Doorway and basin conflict

Decision drawing only. Alternative B is not approved or applied to the source model.

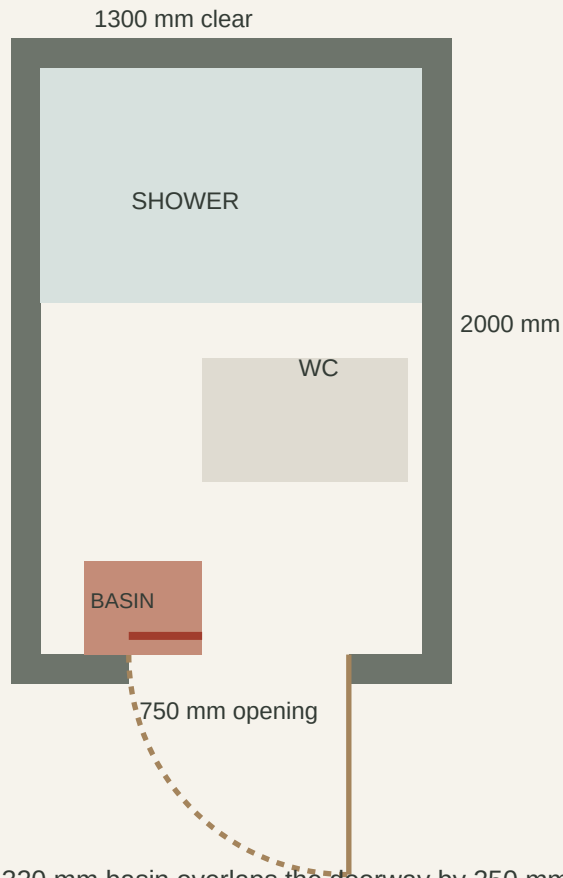
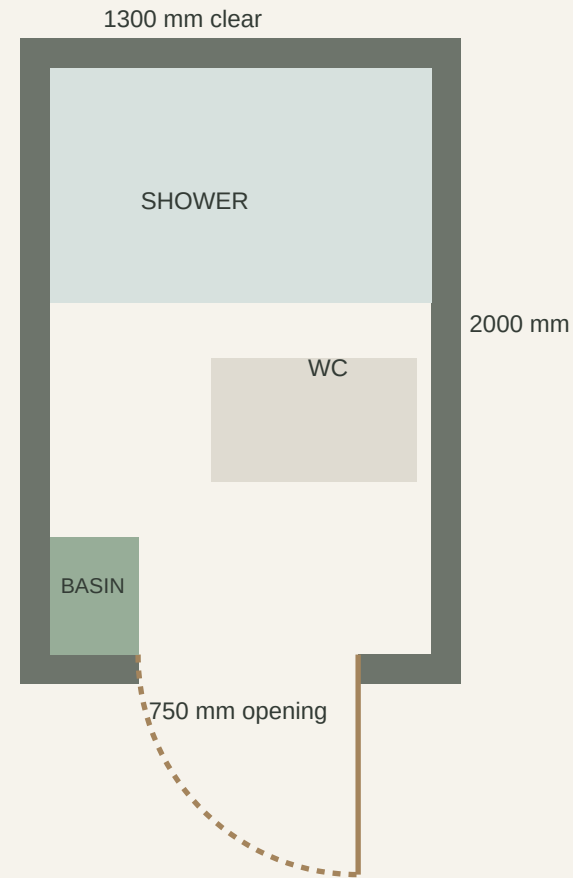
A: 400 x 320 mm basin overlaps the doorway by 250 mm.

B: 400 x 300 mm wall-hung basin rotates onto the south wall in the same corner.

Keeps all walls, door, WC, shower and vents. Requires a short plumbing return and installer verification.
